Reference: Application reference DC/26/0731 (Sub-Phase 2C Road): Consultee Comment Responses

We write on behalf of Legal & General (Strategic Land North Horsham) Limited in response to comments received from consultees on our application seeking the approval of Reserved Matters for the Primary Road through Sub-Phase 2C.

Appendix A – Response Schedule

Planting plan 4 of 7

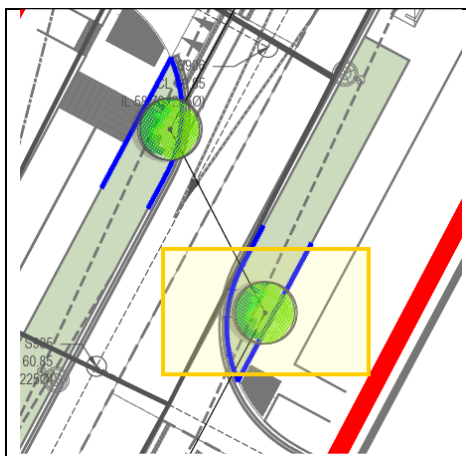
Underground services 11. It is unclear if the proposed trees in some locations have enough clearance from proposed underground services. Some of these lines appear to be visibility splays, others I'm unclear if a proposed underground service is currently clashing with the	The grey lines shown in the background of the screenshots provided are visibility splays rather than underground services.

landscape strategy. Of particular concern will be the street lighting. Please confirm or coordinate and adjust plans, some examples below (but not limited to, please review the full scheme):

All services are proposed to be located beneath the footways, and all sewers are proposed beneath the carriageway. No sewers or services are proposed to run along the landscaped verges.

Where service spurs or crossings are required, these have been coordinated with the proposed tree locations. The lighting design has also been reviewed and will be coordinated with the landscape proposals prior to resubmission to ensure that lighting columns are appropriately positioned in relation to proposed trees and in accordance with WSCC Highway requirements.

The submitted and amended plans demonstrate that the proposed landscape strategy can be delivered without conflict with underground services, sewers, visibility splays or street lighting infrastructure.
